Attorney's Docket No.: 08305/054001/PBIT-0059.00/US

REMARKS

Attached is a marked-up version of the changes being made  
by the current amendment.

Fig 1

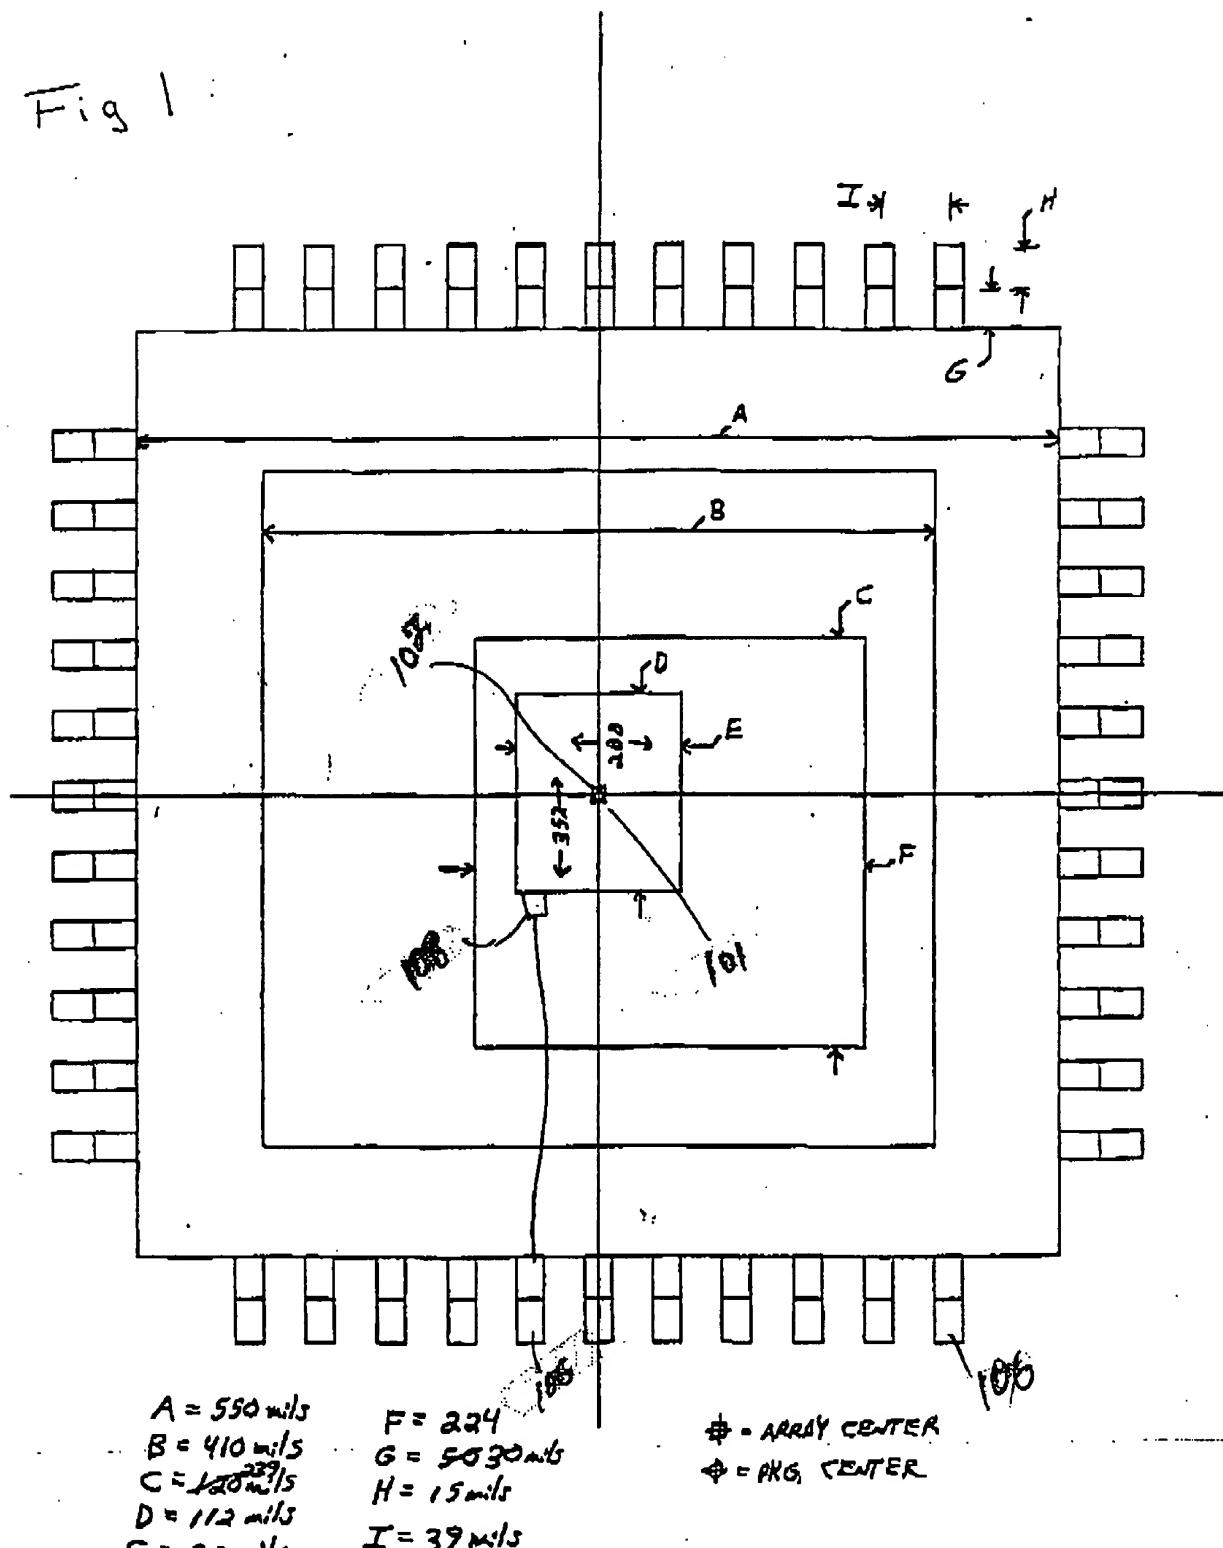
Initially, applicants apologize for the clerical error, in which apparently the original drawings were filed as drawing changes. Attached find new drawing changes including the new reference designations in pink highlighter.

An amendment to the specification referring to all of these designations. In addition, a designation for the array center and the package center have been added, and these are also added to the specification. This should obviate the rejection based on drawings.

Reference numerals for the electrical connections have been added to figure 1 and page 3 which already described these electrical connections.

The final device forms a standard type CMOS die in a totally clear package as shown in Figure 1. The CMOS dies, is, for example, a photosensitive device with electrical connections, for example, an active pixel sensor. The perimeter of the device has these electrical connections, which are connected to the electrical connections 108 on the image sensor chip.

Figure 1 shows the package including different sizes of the different package parts. As shown in figure 1, the package center 102 is inside the array center 101. In addition, the package has a number of different size parameter shown including the size a witch's 550 mills, besides be witch's 410 mills, the size see which is 239 mills, the size of the witch's 112 mills, size the witch's 92 mills, the size F. witch is 224 mills, the size G. witch's 30 mills, the size age witch's 15 mills, and the size by a which is 39 mills.
